**Proposed Temporary Warehouse (Excluding Dangerous Goods Godown) and  
Associated Filling of Land for a Period of 3 Years in "Agriculture" Zone,  
Lots 913 RP (Part) and 914 in D.D.107, Kam Tin, Yuen Long, New Territories**

**(S.16 Planning Application No. A/YL-KTN/1144)**

Responses-to-Comments

DWG NO. ANNEX II VER. 002

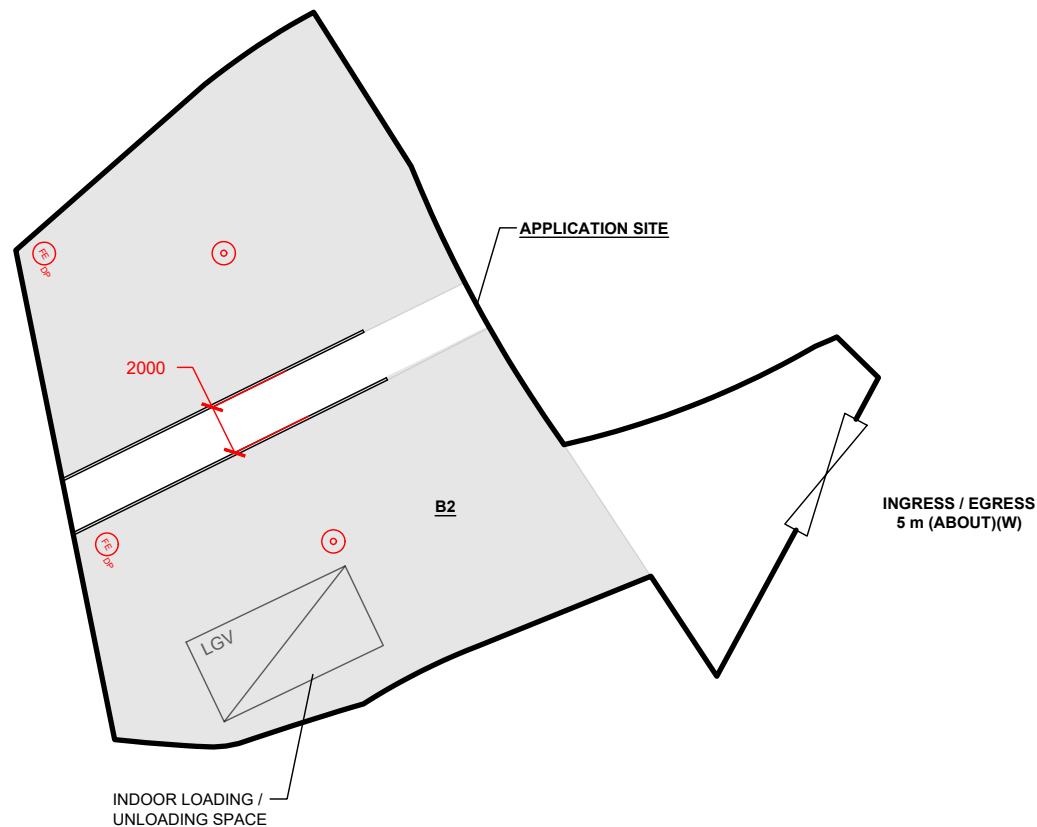
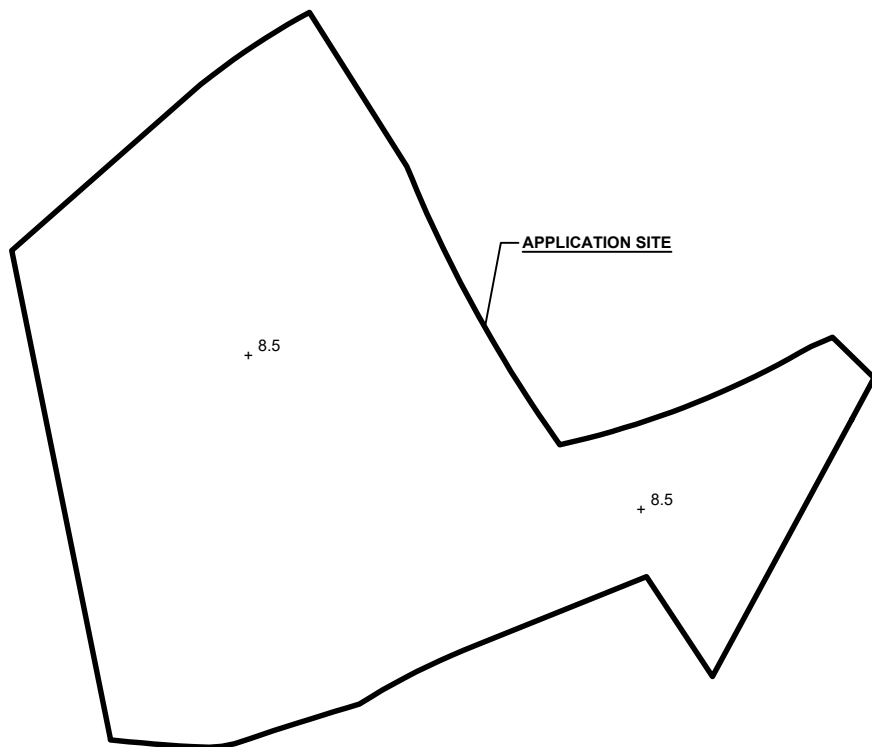
(a)	For enclosed structure with gross floor area not exceeding 230m <sup>2</sup> , only fire extinguisher and Stand-alone Fire Detector shall be provided;	Noted and revised accordingly. Please refer to the revised fire service installations proposal ( <b>Annex II</b> ).

(b)	In relation to i. above, where two or more Stand-alone Fire Detectors are installed in an enclosed structure, all stand-alone detectors shall be interconnected (either wired or wirelessly) such that when one of the stand-alone fire detector is triggered, all connected Stand-alone Fire Detectors shall sound an alarm simultaneously;

(c)	The Stand-alone Fire Detector shall be provided in accordance with the “Stand-alone Fire Detector General Guidelines on Purchase, Installation & Maintenance [Sep 2021]”; and

**Plan 5**  
Filling of Land Area

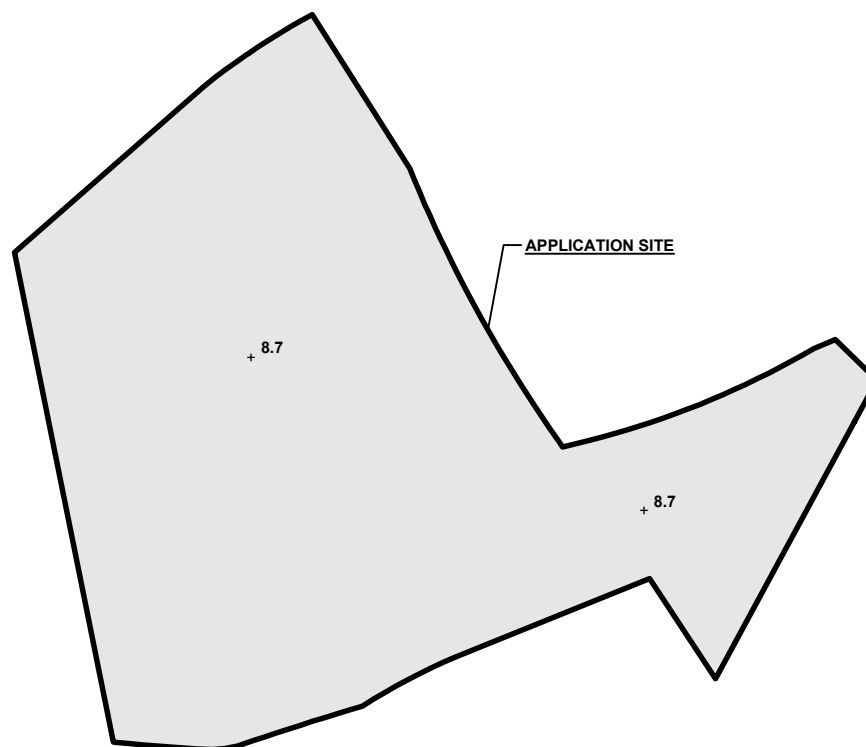
(a)	<u>(A) Condition of the Subject Site</u>  (i) The ground to the north and east of the application site is generally higher. Since the overland flow from the adjacent lands shall be probably intercepted, external	Please be confirmed that the existing site level is +8.7mPD ( <b>Plan 5</b> ). The Site has already been hard-paved and no further filling of land will be carried out within the Site during the planning approval period. The applicant will

<p>catchment shall be considered in the calculation. According to the topography around the subject site, the catchment area shall be greater than the one adopted in the submitted hydraulic calculation. The applicant should update hydraulic calculation.</p> <p>(ii) Drawings (No. PLAN 5 Rev.1 &amp; D02): The applicant should clarify whether the proposed site formation level of the application site is +8.5mPD or +8.7mPD. The proposed site formation level is higher than level of existing ground adjoining the application site. The applicant should update sectional views of the site to clarify the relationship between the proposed drainage system, the proposed site formation level and existing ground level. In general, peripheral surface channels should be provided at the lower level to collect the surface runoff of both the application site and the overland flow from the adjacent lands.</p>	<p>submit a revised drainage proposal after planning approval has been granted by the Board.</p>
